**SOLICITATION AMENDMENT
MODIFICATION DE L'INVITATION**

RAISED TO ADD ADDENDUM #01 AND
CORRESPONDING DRAWINGS TO THE
TENDER

Title - Sujet Greenstone NRCAN/Parks Fit-up	
Solicitation No. - N° de l'invitation EW038-161131/A	Amendment No. - N° modif. 001
Client Reference No. - N° de référence du client NRCAN EW038-161131	Date 2015-10-27
GETS Reference No. - N° de référence de SEAG PW-\$PWU-107-10589	
File No. - N° de dossier PWU-5-38195 (107)	CCC No./N° CCC - FMS No./N° VME
Solicitation Closes - L'invitation prend fin at - à 02:00 PM on - le 2015-11-03	Time Zone Fuseau horaire Mountain Standard Time MST
F.O.B. - F.A.B. Plant-Usine: <input type="checkbox"/> Destination: <input checked="" type="checkbox"/> Other-Autre: <input type="checkbox"/>	
Address Enquiries to: - Adresser toutes questions à: Anthony, Mary	Buyer Id - Id de l'acheteur pwu107
Telephone No. - N° de téléphone (780) 237-7582 ()	FAX No. - N° de FAX (780) 497-3510
Destination - of Goods, Services, and Construction: Destination - des biens, services et construction:

2.0 ARCHITECTURAL

2 NEW MAIN FLOOR TENANT IMPROVEMENTS - CEILING
M4 SCALE: 1:100

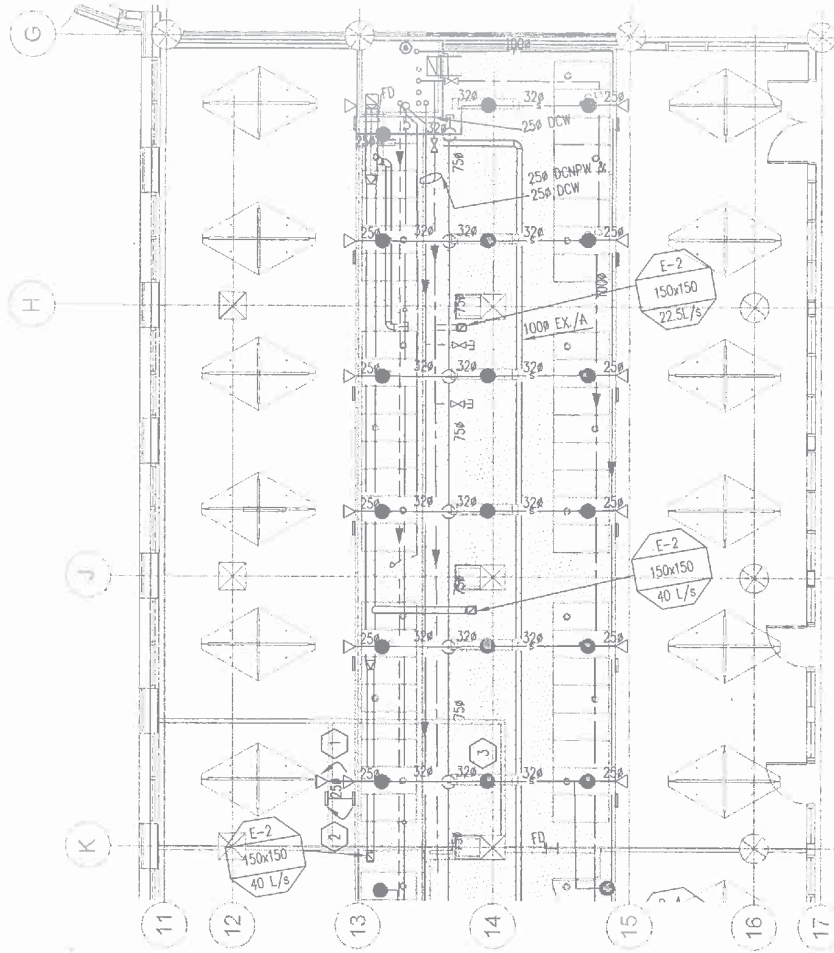
- 1 RELOCATE SPRINKLER HEAD AND PIPING AS INDICATED.
- 2 RELOCATE RETURN AIR GRILLE FOR NEW OFFICE. EXTEND 300x125mm DUCT WORK TO NEW LOCATION.
- 3 CONFIRM SPRINKLER HEAD MAINTAINS 100mm CLEARANCE FROM NEW WALLS.
- 4 RELOCATE IN-FLOOR SUPPLY DIFFUSERS AS SHOWN.

4 EXISTING MAIN FLOOR TENANT IMPROVEMENTS - FLOOR

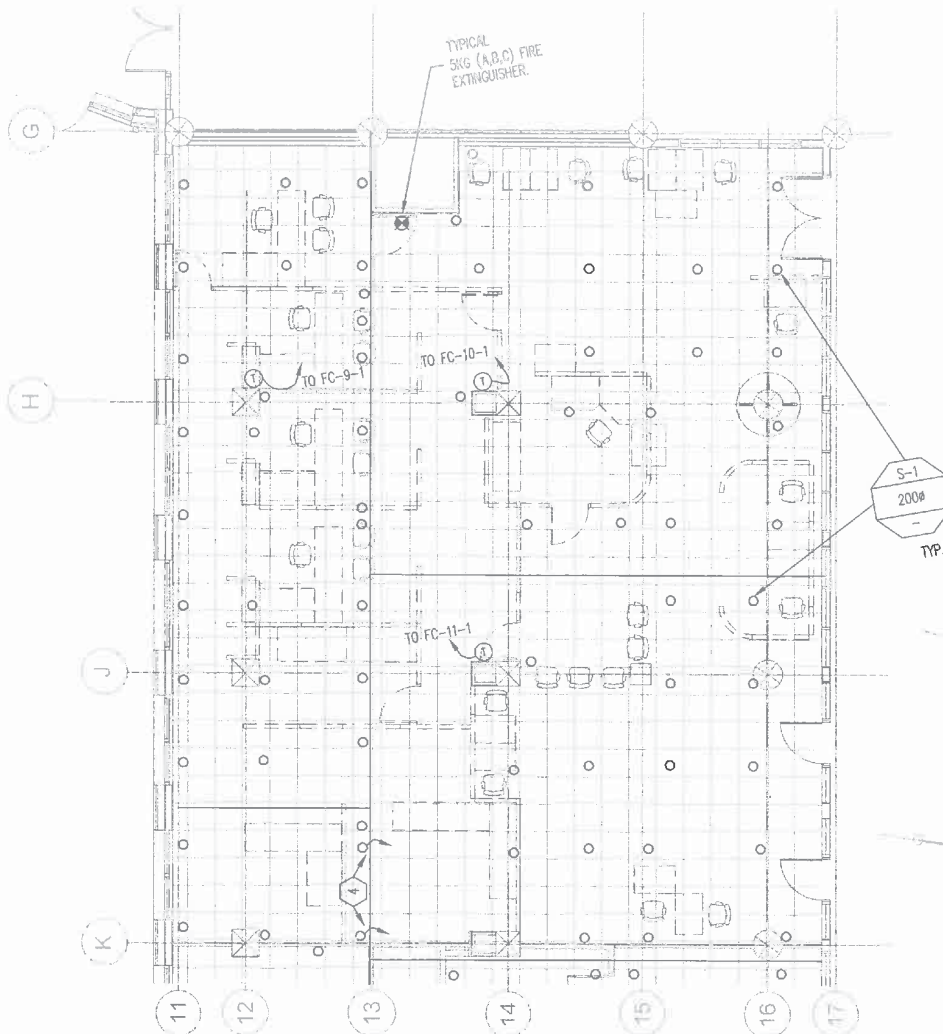
- 1 RELOCATE SPRINKLER HEAD AND PIPING AS INDICATED.
- 2 RELOCATE RETURN AIR GRILLE FOR NEW OFFICE. EXTEND 300x125mm DUCT WORK TO NEW LOCATION.
- 3 CONFIRM SPRINKLER HEAD MAINTAINS 100mm CLEARANCE FROM NEW WALLS.
- 4 RELOCATE IN-FLOOR SUPPLY DIFFUSERS AS SHOWN.

MSK-03

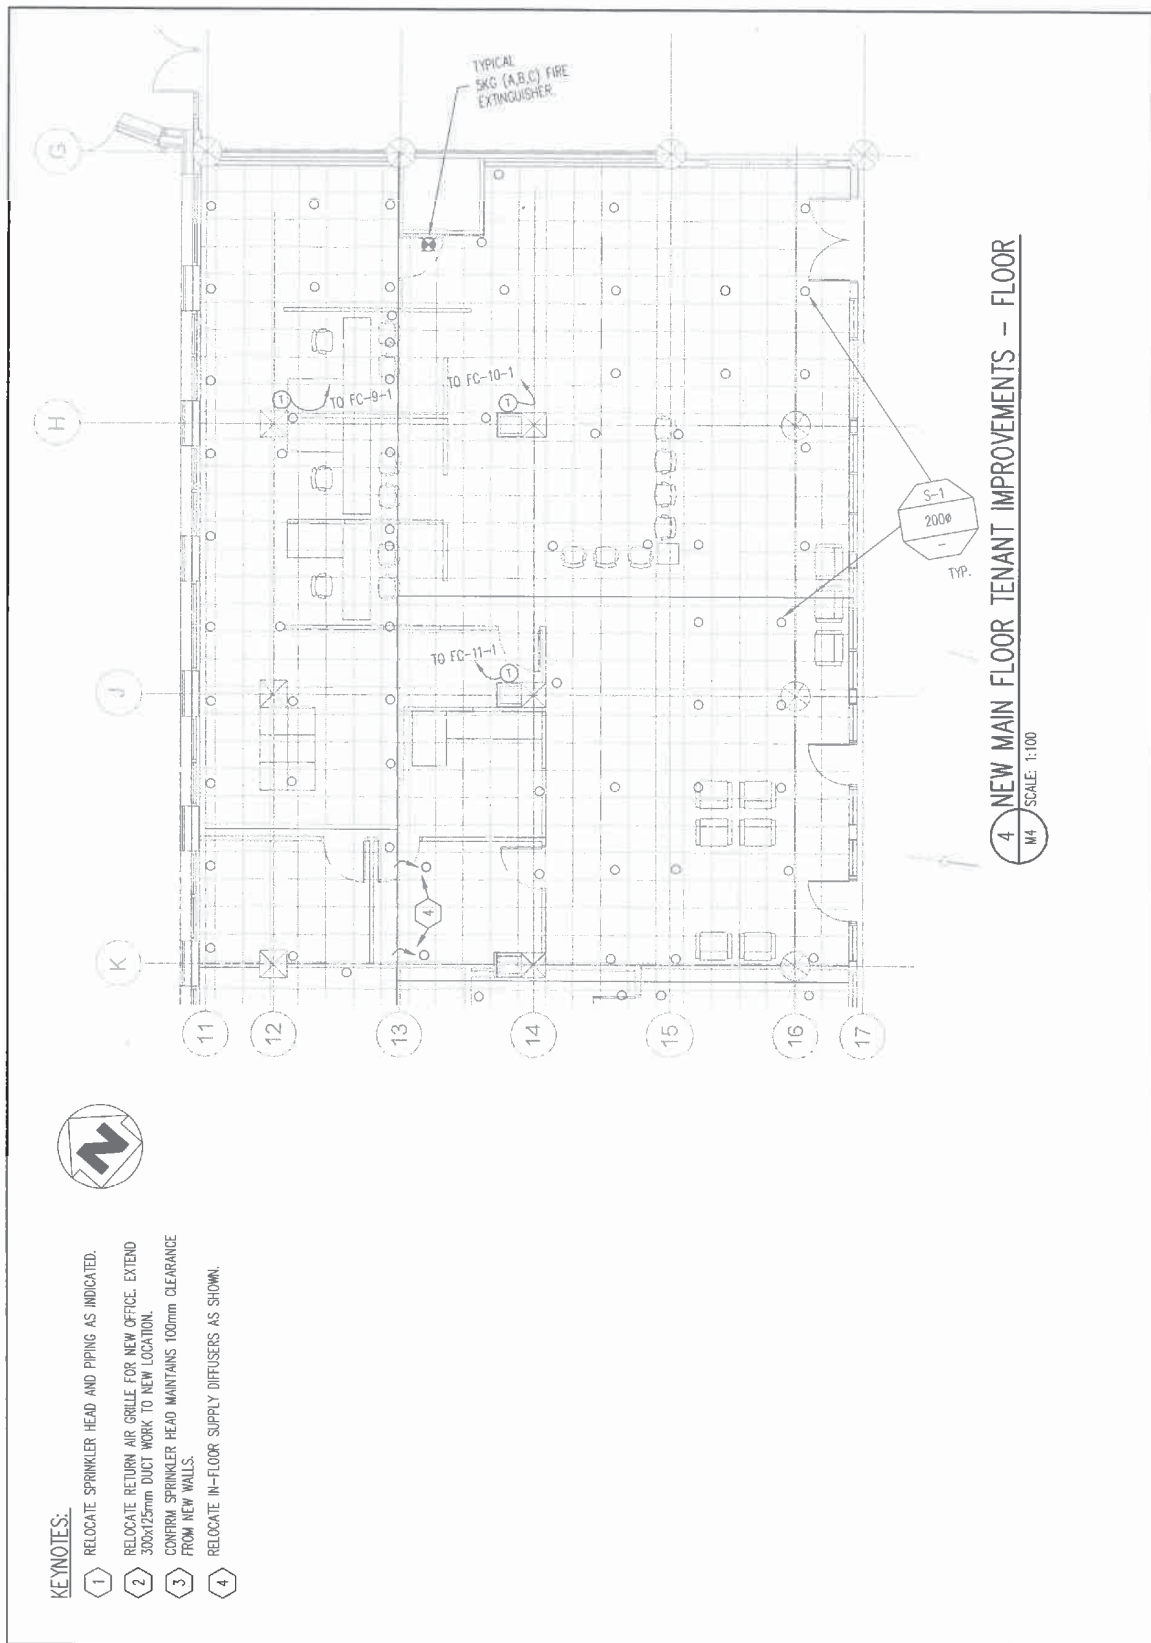
- 1 RELOCATE SPRINKLER HEAD AND PIPING AS INDICATED.
- 2 RELOCATE RETURN AIR GRILLE FOR NEW OFFICE. EXTEND 300x125mm DUCT WORK TO NEW LOCATION.
- 3 CONFIRM SPRINKLER HEAD MAINTAINS 100mm CLEARANCE FROM NEW WALLS.
- 4 RELOCATE IN-FLOOR SUPPLY DIFFUSERS AS SHOWN.

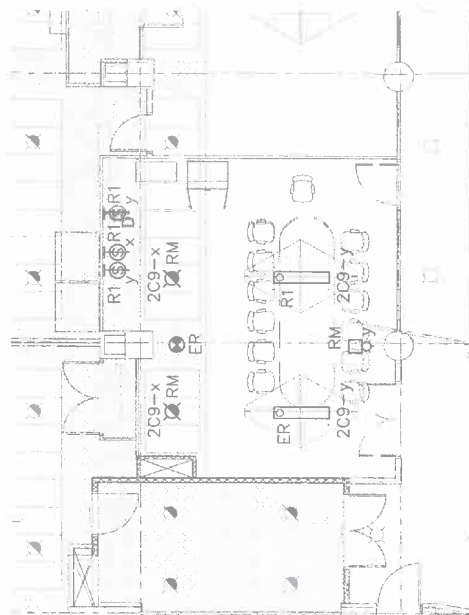
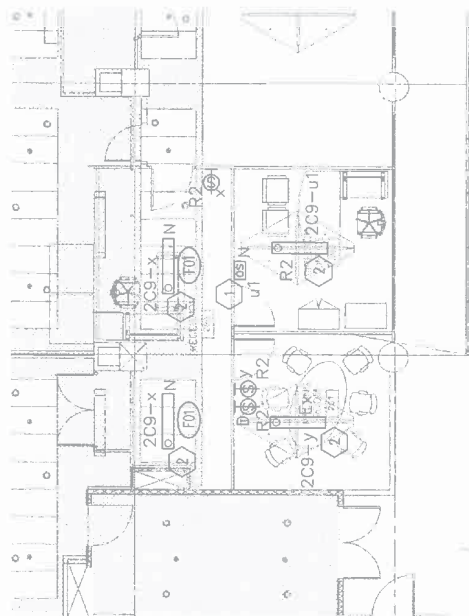
- PROVIDE A WALL MOUNTED OCCUPANCY SENSOR WITH A SWITCH
- PROVIDE 3 LAMPS IN THE FIXTURE

**ASK
002**

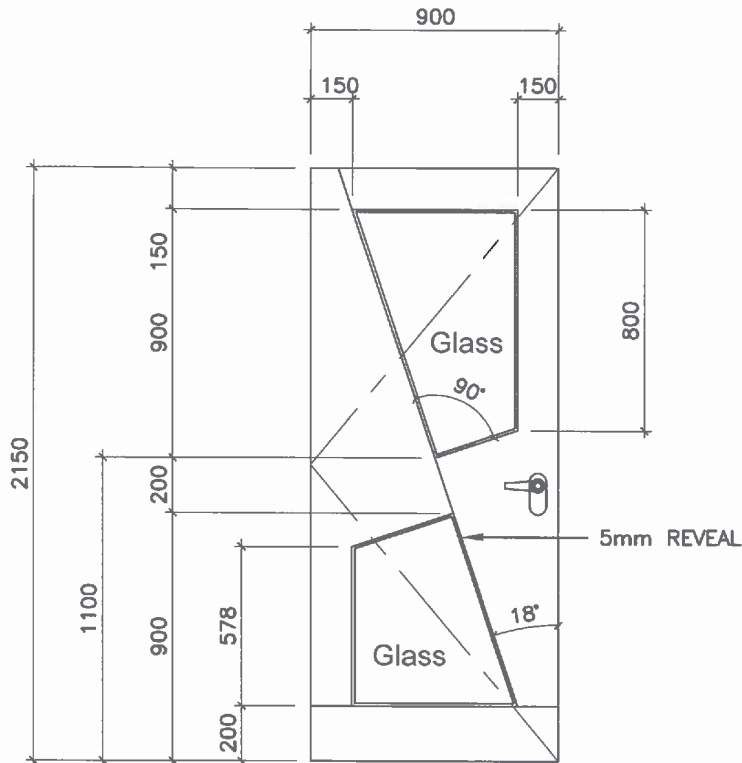
- .1 Subject: Service Canada - Main Floor Fit Up
Refer: Contract Documents - Section 08 15 00 & Section 08 71 00
Instructions: .1 Refer to ASK's 003 through 005. Refer to ASK 02 for new wood door elevation.
.2 Provide demolition and new fit up as indicated on ASK's.
.3 Provide new doors and Finish Hardware as indicated;
Door 101a, 101b and 102: Hardware Group 2

- .3 Subject: Service Canada - Second Floor Fit Up
Refer: Contract Documents - Section 08 15 00 and Section 08 71 00.
Instructions: .1 Refer to ASK's 006 through 008. Refer to ASK 02 for new wood door elevation.
.2 Provide demolition and new fit up as indicated on ASK's.
.3 Provide new doors and Finish Hardware as indicated;
Door 260, 261 and 262: Hardware Group 2
